NOTICE OF ADDENDUM ADDENDUM 1

CONTRACT NO. 8348

PROJECT:
2019 DOOR
CREEK PARK
TENNIS COURTS
PHASE II

SHEET NUMBER:
1.4

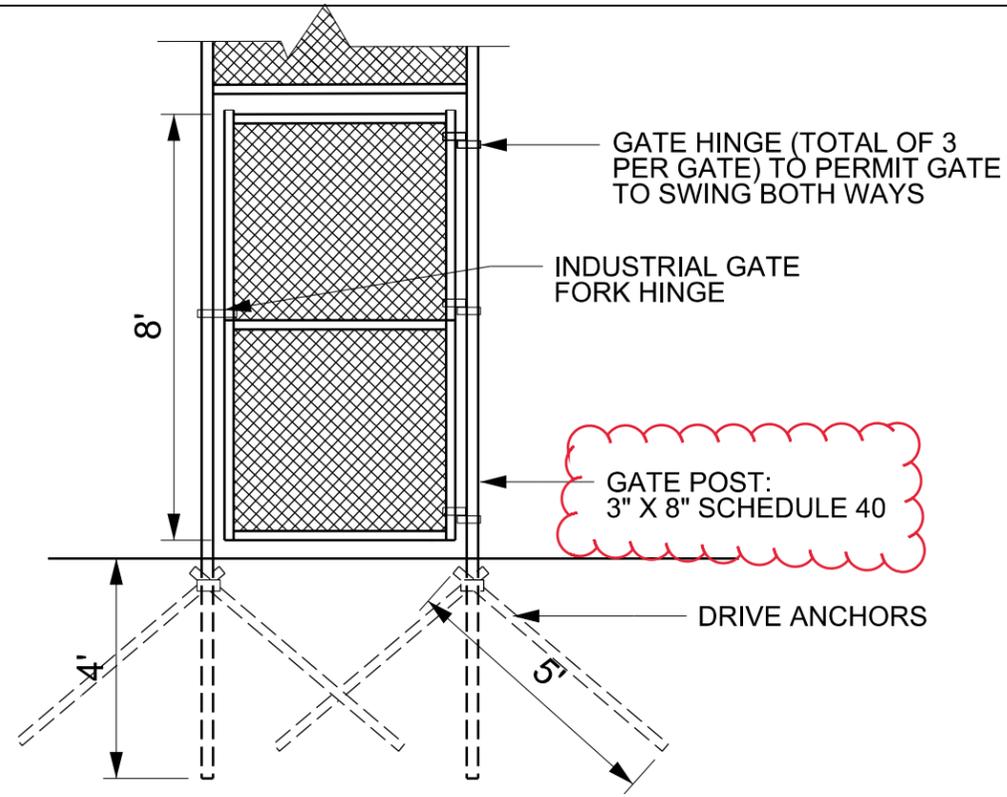
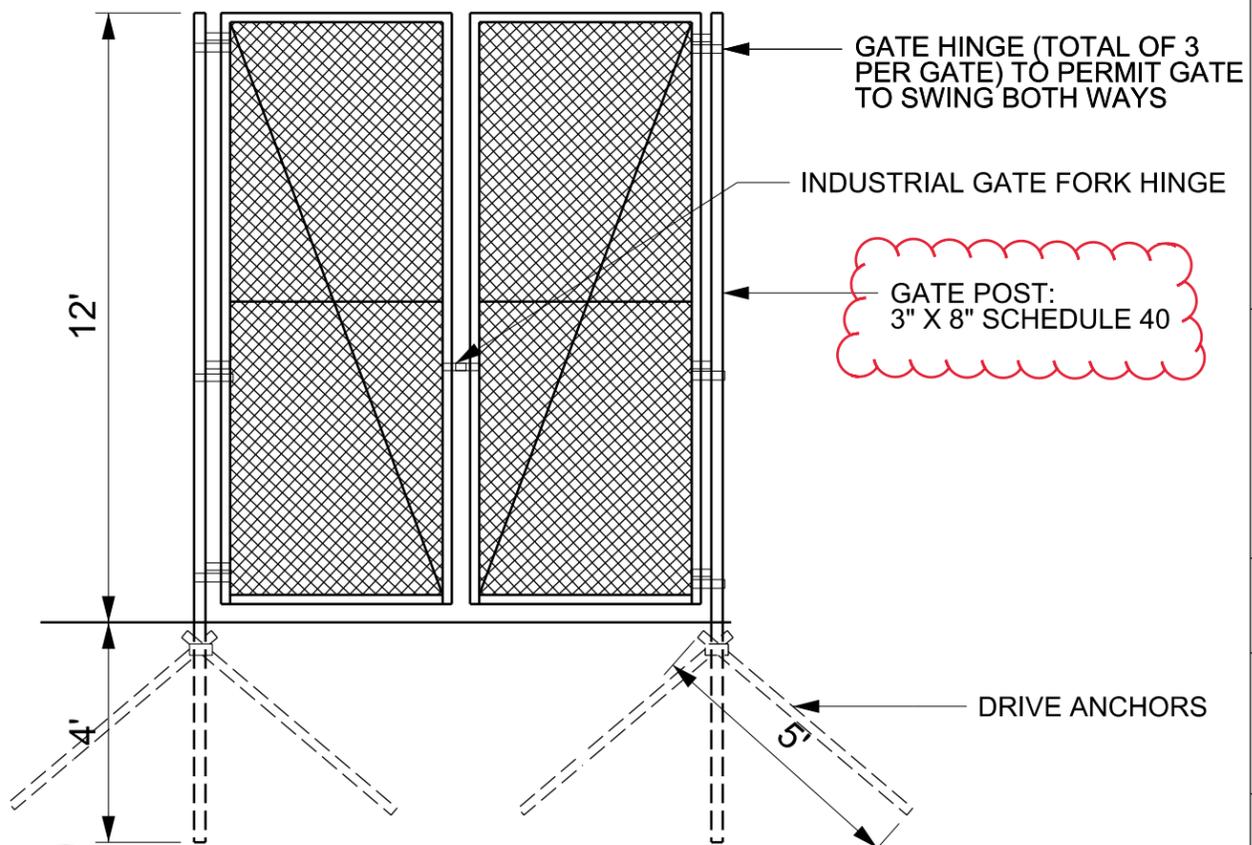
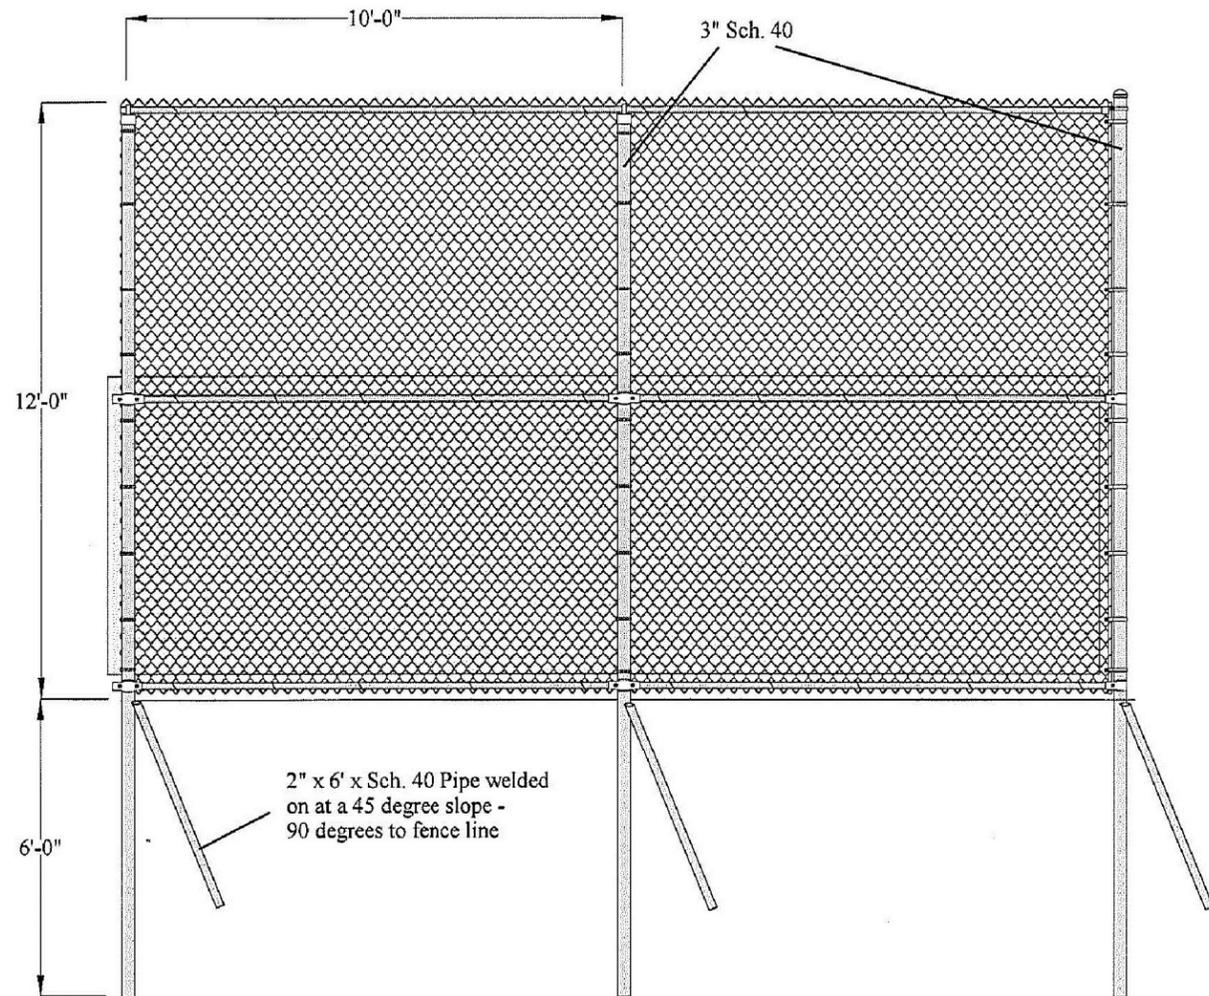
Per Sheet 1.4, all gate posts shall be three inch (3”) outside diameter (O.D.)
